FINAL CONSTRUCTION CHANGES COMPLETED
Larry J. Anderson
PROJECT OR RESIDENT ENGINEER
DATE 1-24-75

VILLAGE OF MAPLEWOOD
MINNESOTA
LYDIA AVENUE
ENGINEERING DEPARTMENT

VILLAGE PROJ. NO. 72-17
M.S.A.S. PROJ. NO. 138-116-05
27-111 3365

TYPICAL SECTION

TYPICAL SECTION LYDIA AVENUE

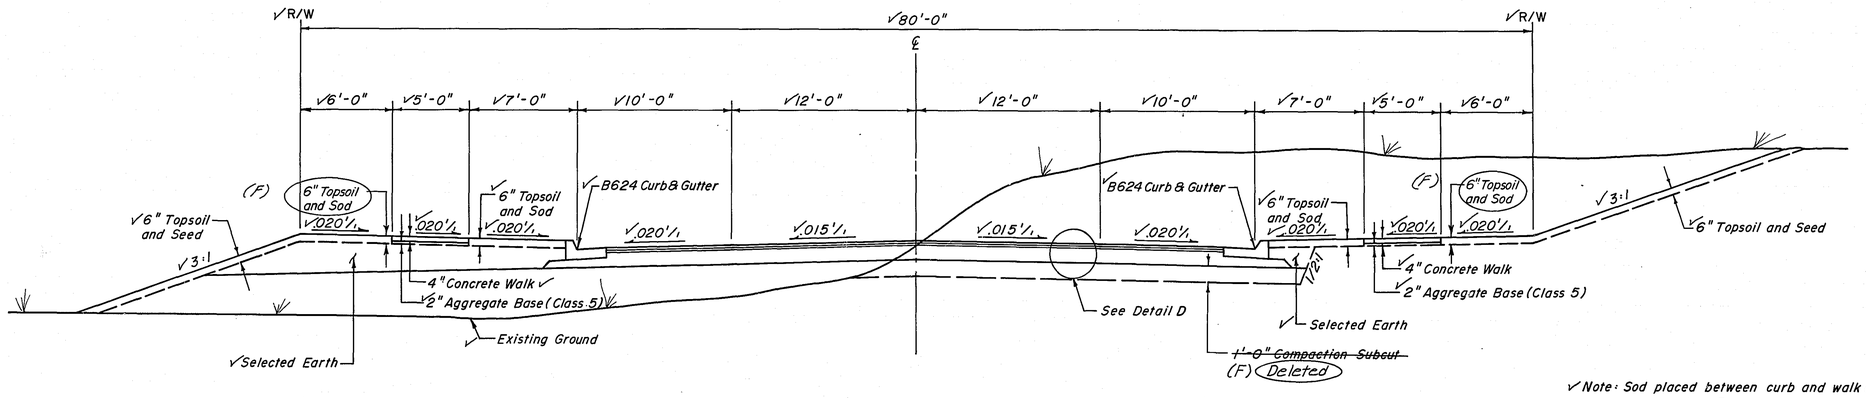
✓Note: Sod placed between curb and walk and on slopes steeper than 3:1. Seed all other disturbed areas.

(F) Sod placed between R/W line and walk.

✓ STA. 51+20 TO STA. 75+~~64~~
(F) 84

DETAIL C
TYPICAL SECTION
CATCH BASIN IN GUTTER

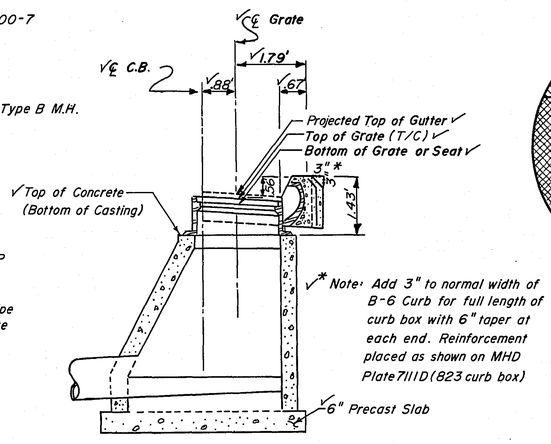
✓* Note: Add 3" to normal width of B-6 Curb for full length of curb box with 6" taper at each end. Reinforcement placed as shown on MHD Plate 7111D (823 curb box)

✓MHD Grate Frame Casting No. ~~810~~ (F) 801
✓MHD Grate No. 810
✓City of St. Paul Dep't. of Pub. Wks Curb Box Casting 'M'

PLANNED CONSTRUCTION
✓STA. 50+18 TO STA. 63+00
SHEET 6 OF 28 SHEETS

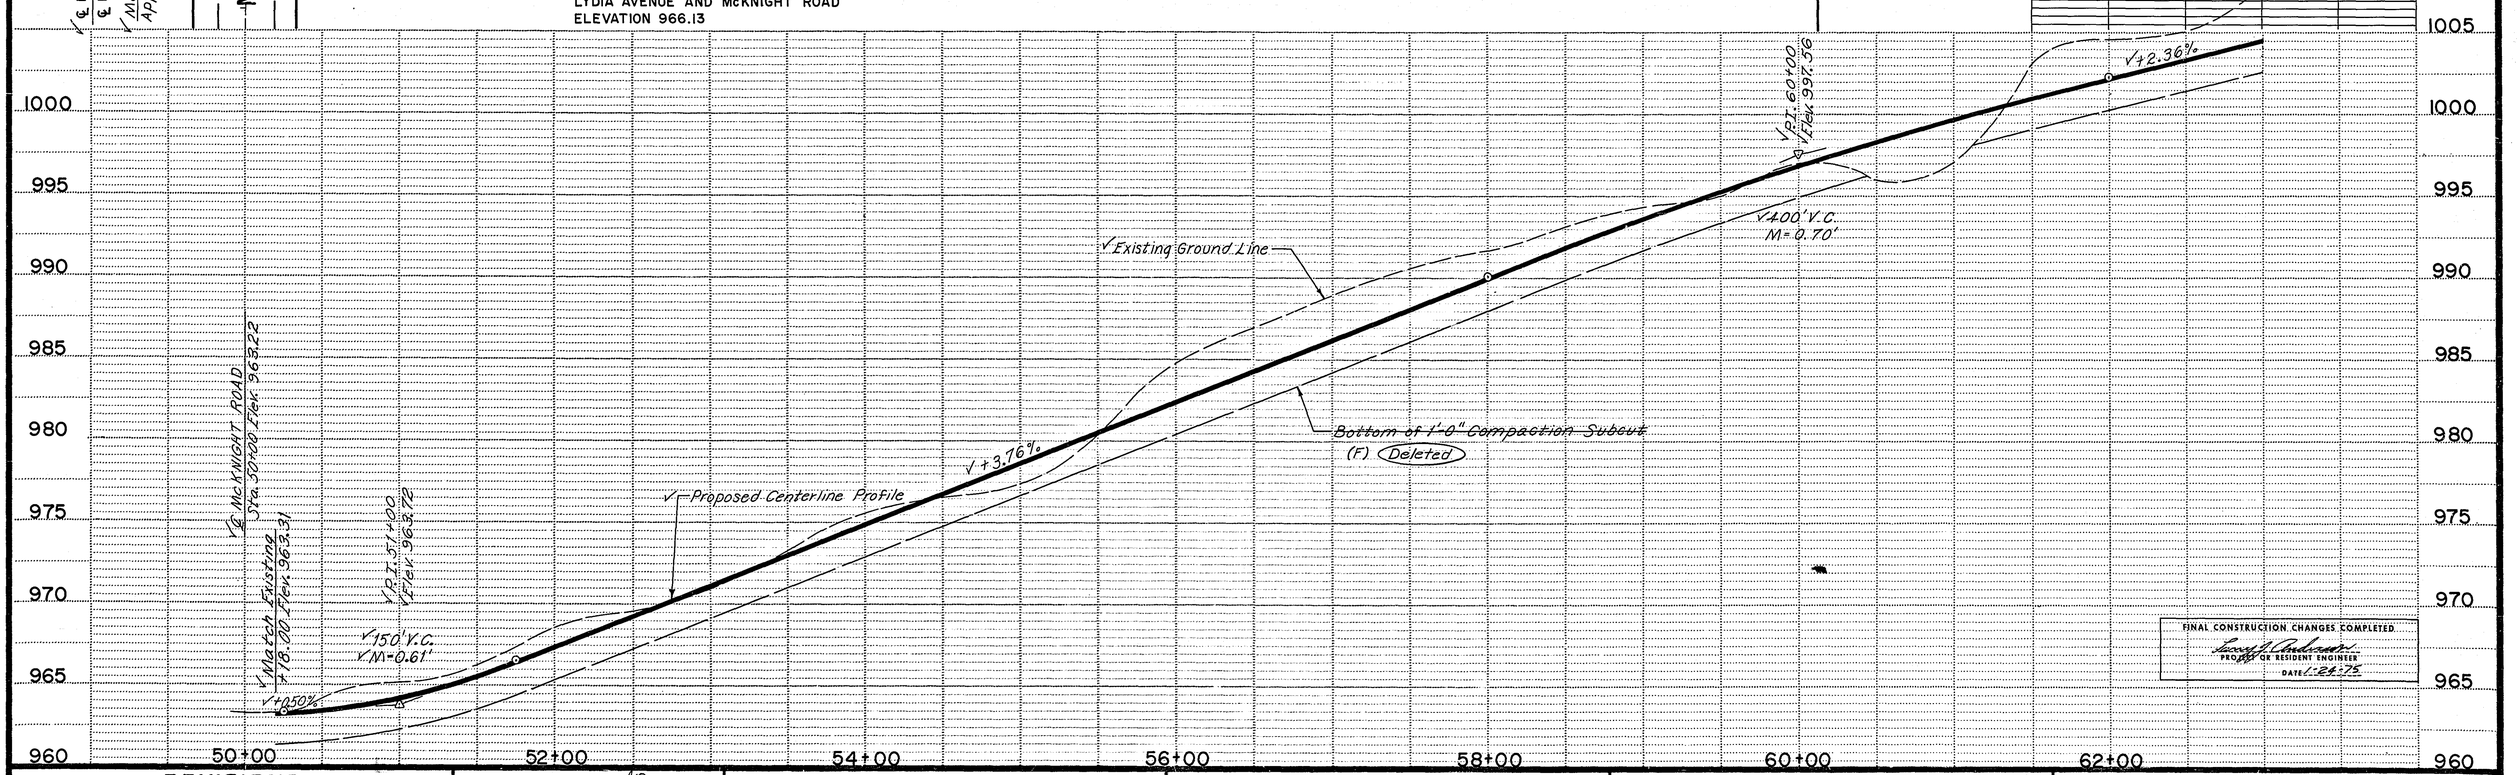
Note:
✓1. All radius dimensions are measured to back of curb.
~~2. B6 Bituminous Curb to be painted white.~~ (F) Deleted
✓3. All 30' radius curb returns shall be ~~transitioned from B624 section to B618 section.~~

(F) Edge Bit. Pavement
(F) End 5' Conc. Sidewalk Beg. 5' Bit. Sidewalk Sta. 57+90
(F) Grading Completed for Apron
✓℄ LYDIA AVENUE STA. 58+23.73
✓℄ FUTURE STREET STA. 0+00.00

(F) 30' 311.76' ✓Construction Easement
~~50' Rad. (72.67' left)~~
~~Sta. 50+68.96~~
(F) 52.67
(F) 48.96 ✓Right of Way
25' 25'
155.87' 155.88' 152.22' 176.04' 159.24' 170.00'
✓40' ✓60' ✓60' ✓60' ✓40'
(F) Bituminous Pavement
~~End Construction~~
(52.67' Left)
(F) ~~Sta. 57+77.06~~
~~30' Radius (52.67' Left)~~
(F) End 5' Bit. Sidewalk Beg. 5' Conc. Sidewalk Sta. 58+55
~~30' Radius (52.67' Left)~~
~~Sta. 58+70.40~~
(F) 30' Radius deleted.
✓Back of Curb

Right of Way ✓Saw existing bituminous before abutting new pavement. 40' ROAD
✓89°46'20" 89°40'00"
✓40' ✓40' ✓40' ✓40'
LYDIA AVENUE 50 ℄ LYDIA 55 60 AVENUE
✓End B6 Bit. Curb Begin B624 C.C.&G Sta. 51+20
(F) End B624 C.&G. Beg. B6 Bit. Curb Sta. 57+79
(F) End B6 Bit. Curb Beg. B624 C.&G. Sta. 58+72
✓Toe of Gutter
✓Right of Way ✓5' Concrete Walk ✓Back of Curb ✓Right of Way
✓Limits of possible simultaneous grading (Sta. 60+00 to Sta. 74+50)
✓50' 300.01'
MATCH LINE SHEET NO. 7
(F) 30' (F) 52.67'
~~50' Rad. (72.67' Right)~~
~~Sta. 50+68.25~~
25' 25'
(F) 48.25
980.01' ✓80'
✓Construction Easement
CHARLES L. WATTERSON et al.

✓℄ LYDIA AVENUE STA. 50+00.00 = ℄ McKNIGHT ROAD STA. 39+51.20
✓Match Existing Roadway Approximate Sta. 50+18
✓Right of Way
McKNIGHT 38 ROAD
✓Right of Way
✓Begin B6 Bituminous Curb (~~72.67'~~ Right) Sta. 50+17.58
(F) 52.67
INDEPENDENT SCHOOL DISTRICT NO. 622
